Explanation of Significant Differences to the Final Record of Decision for Parcel C

**Hunters Point Shipyard
San Francisco, California**

October 2014

**RESPONSE TO COMMENTS ON
DRAFT EXPLANATION OF SIGNIFICANT DIFFERENCES TO THE
FINAL RECORD OF DECISION FOR PARCEL C, HUNTERS POINT NAVAL
SHIPYARD, SAN FRANCISCO, CALIFORNIA**

Tier 1 Excavation Area 23-1 (Sheet 7)

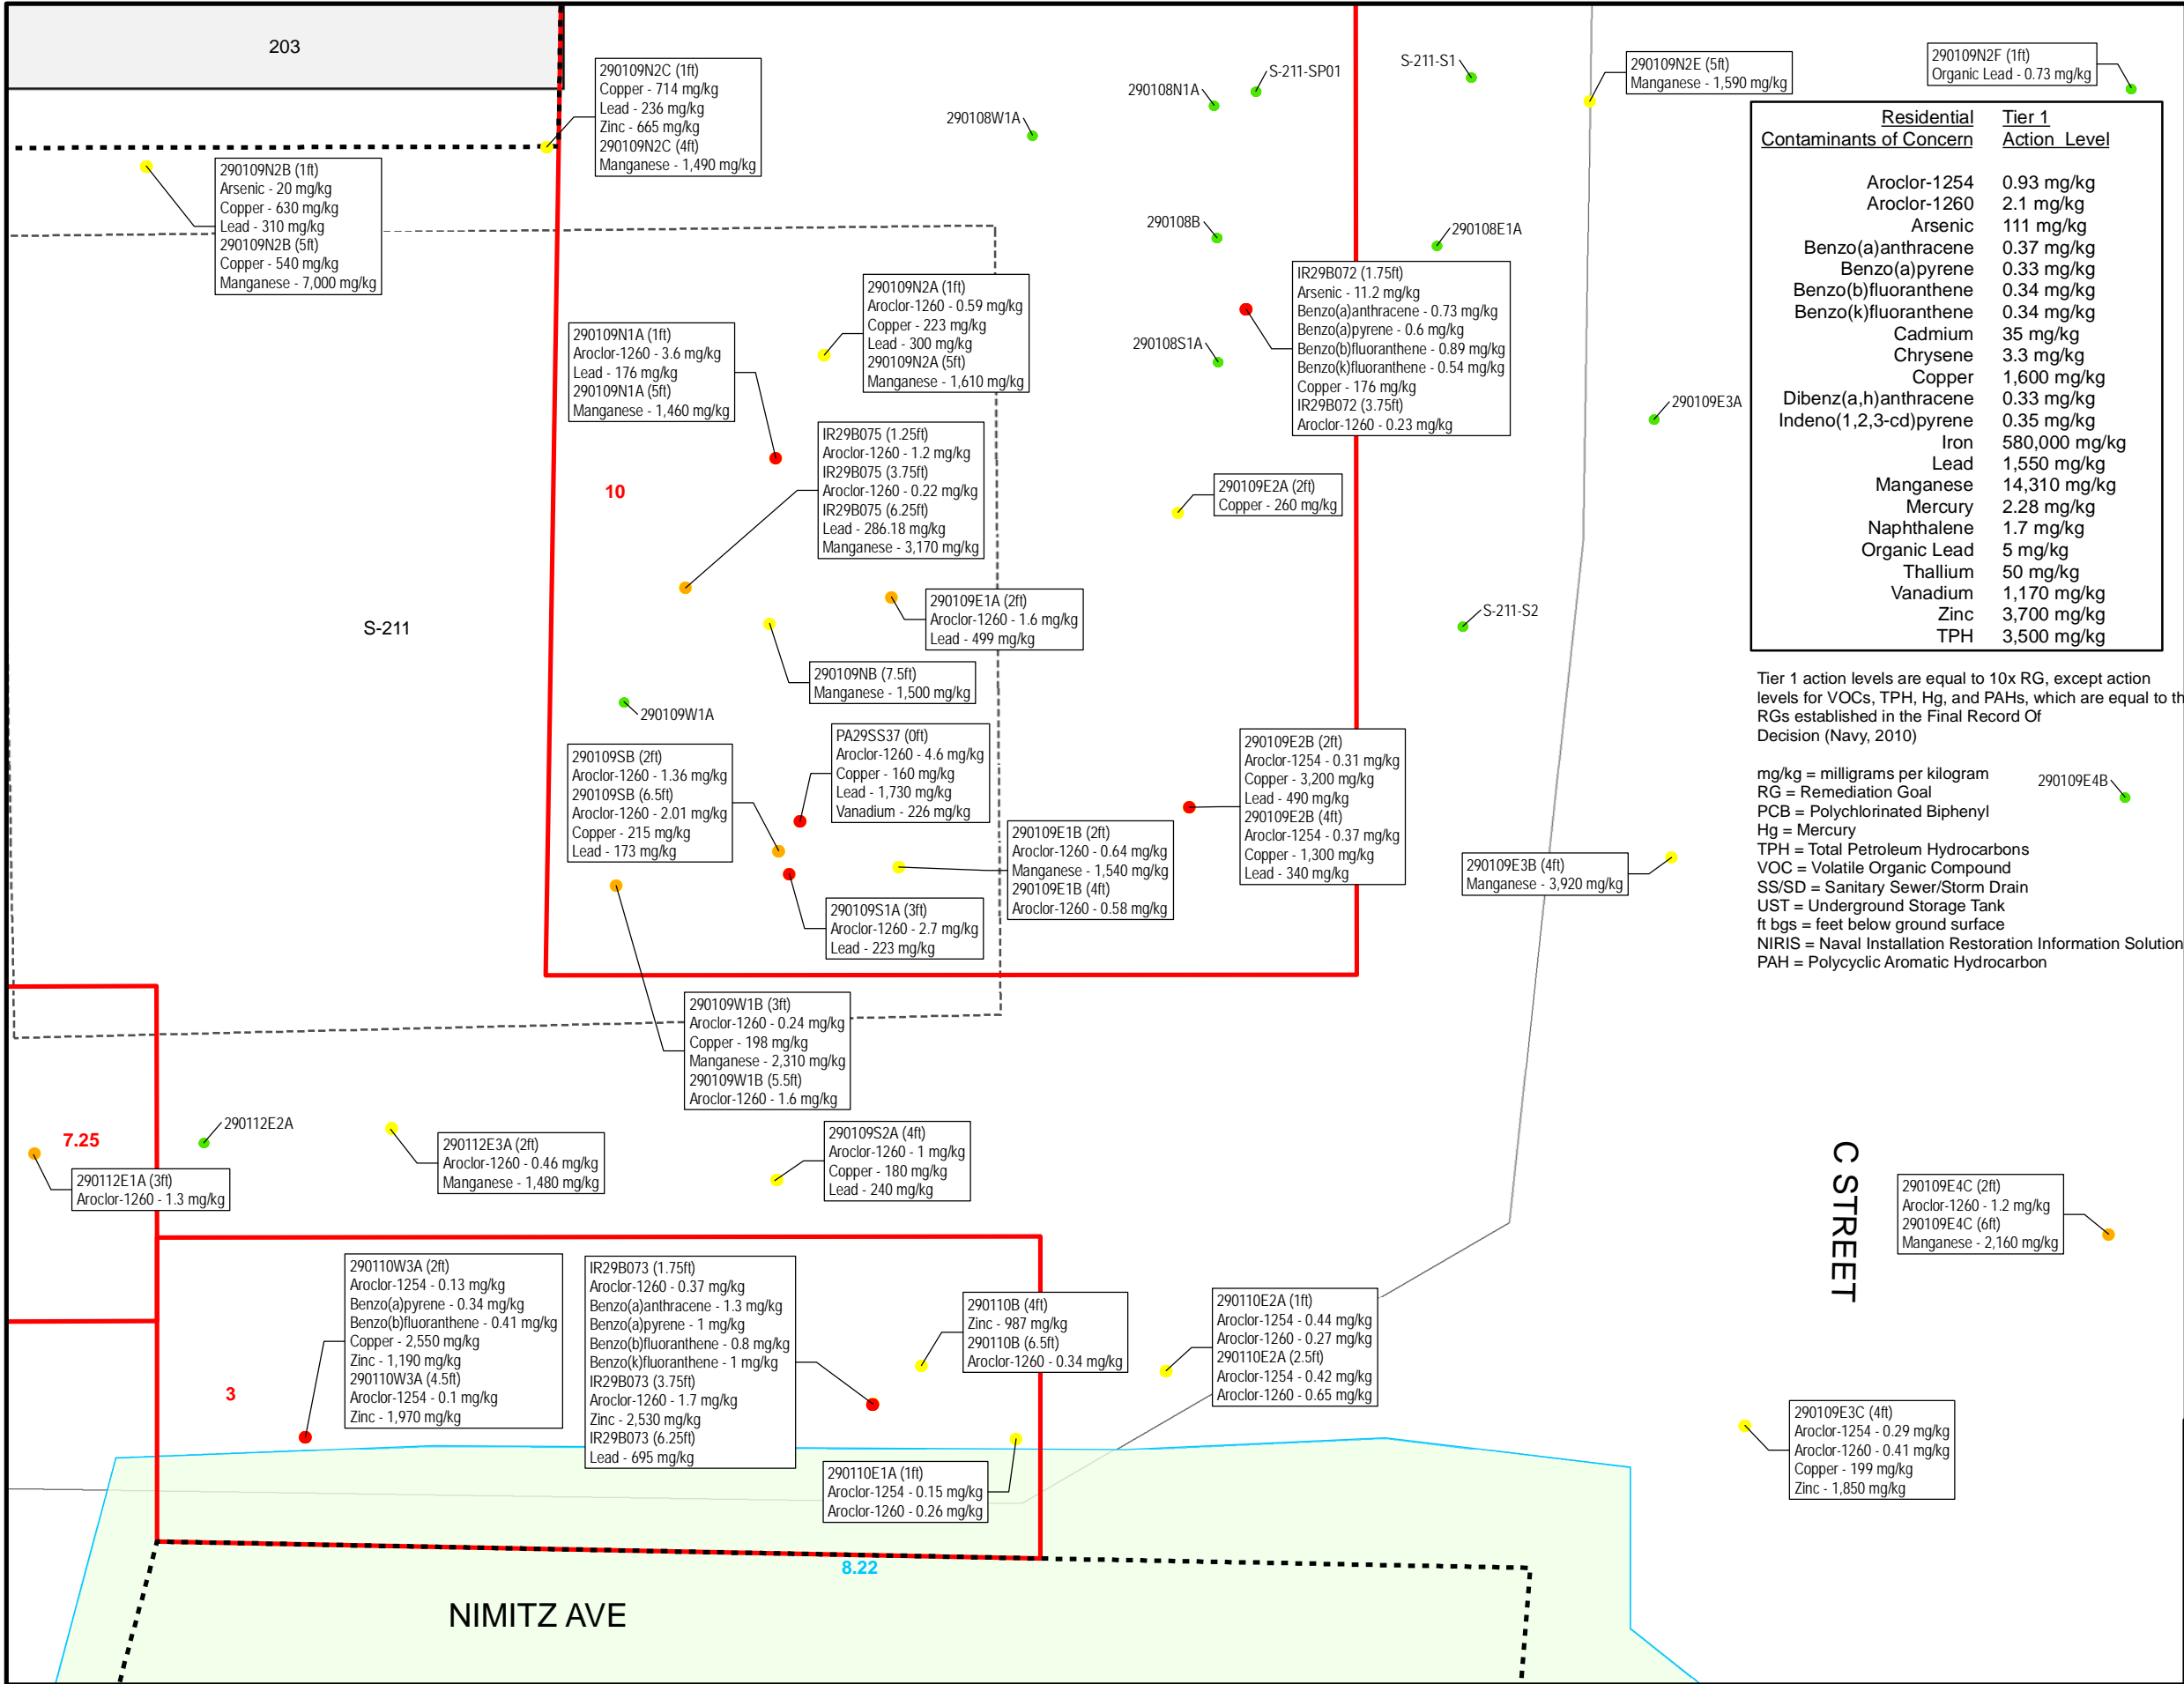
6.	Figure 4-10, Tier I Excavation Area 23-1 (Sheet 7)	Location 290109W6D is denoted with a red dot, indicating that the soil sample collected from 3 feet bgs at this location exceeded the RG for PAHs, but it is not included within an excavation area. EPA requested excavation of this area at the meeting where the tiered approach was discussed. Please ensure this location is excavated.	The area where Sample number 290109W6D was collected was excavated as part of the Remedial Action. This was verified with the excavation contractor. The figure will be updated to reflect excavation in this area.

Excavation Area 24-3

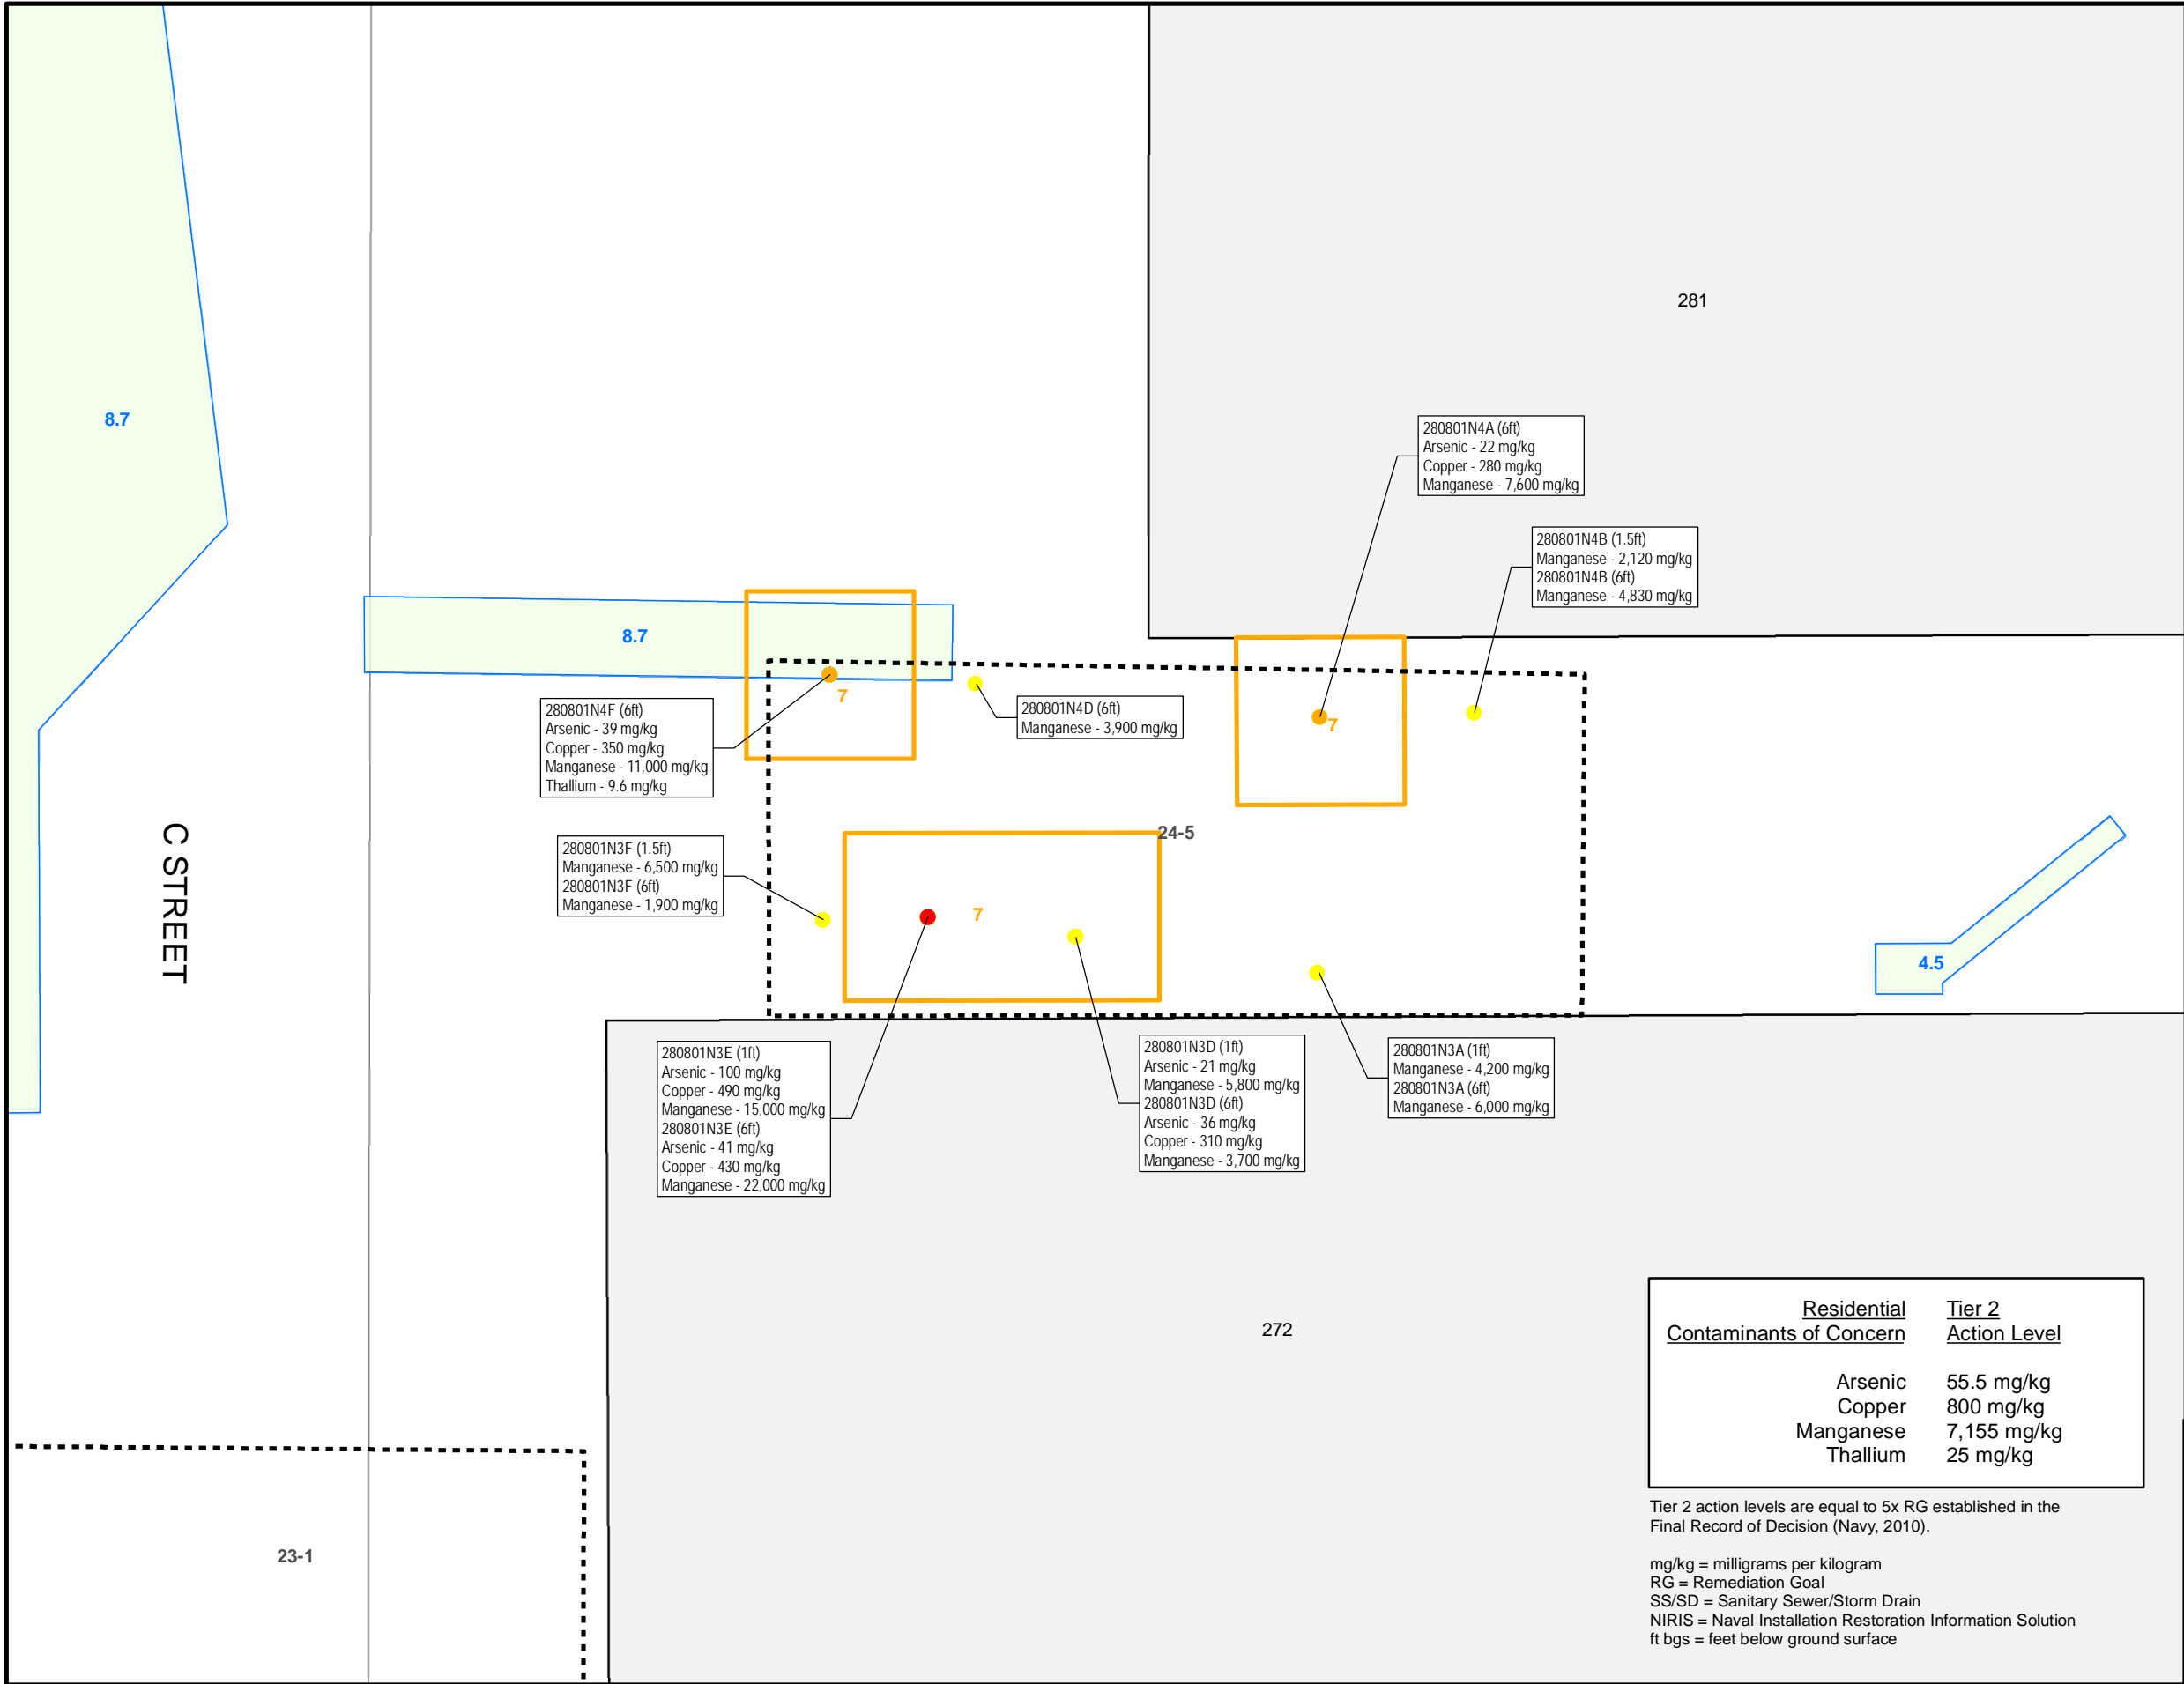
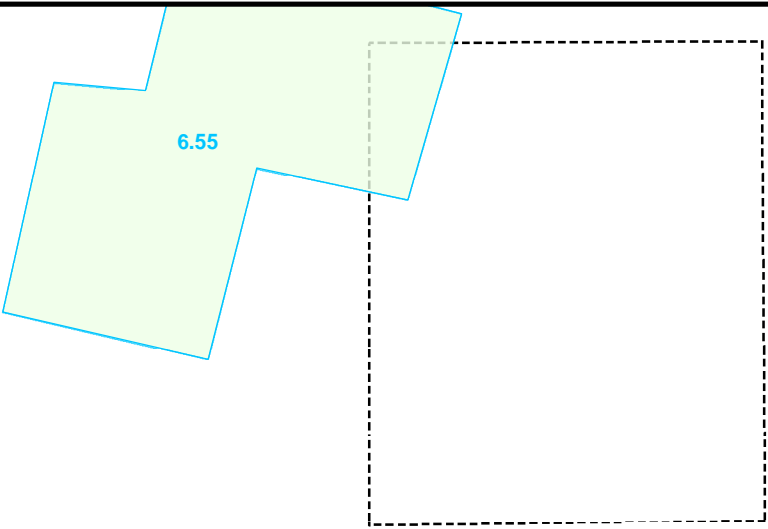
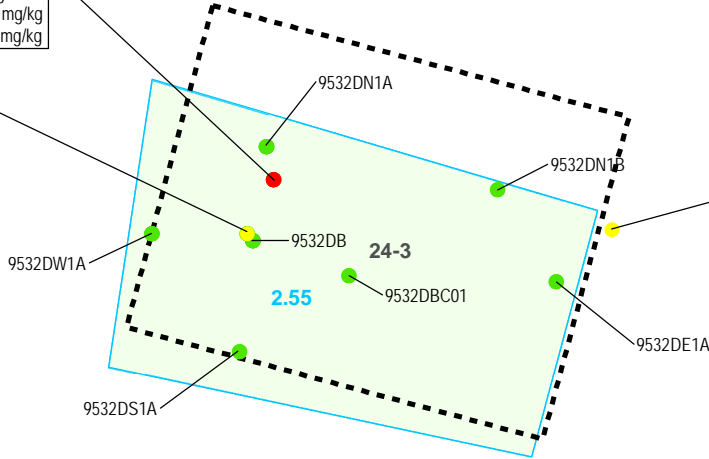
13.	Section 4.2.2 Soil Excavation 24-3	The ESD proposes to remove this excavation area such that no further excavation would take place. However, Figure 4-12 shows PAH concentrations above RGs. Leaving soil with PAH concentrations exceeding RGs is not consistent with the proposed tiered approach. Please revise the text to provide justification for removing this excavation area given then PAH exceedances.	Although residual polycyclic aromatic hydrocarbon (PAHs) are detected at Excavation Area 24-3 at concentrations exceeding RGs, the cumulative residual risk for Excavation Area 24-3 (excluding arsenic and vanadium, for which concentrations are statistically similar to background) does not exceed the risk management range of 1E-04 to 1E-06 and the hazard index (HI) is less than the threshold of 1. In addition, detections of residual PAHs above the RG were at concentrations slightly exceeding RGs and were limited to one location at area 24-3 (IR28B243, 8.75 feet bgs); residual risks were estimated using residual PAH detections at this location as exposure point concentrations (EPCs), as 95 percent UCL EPC results from USEPA's ProUCL software defaulted to the maximum detected concentration. This approach likely results in an overly conservative estimate of residual risks because it assumes
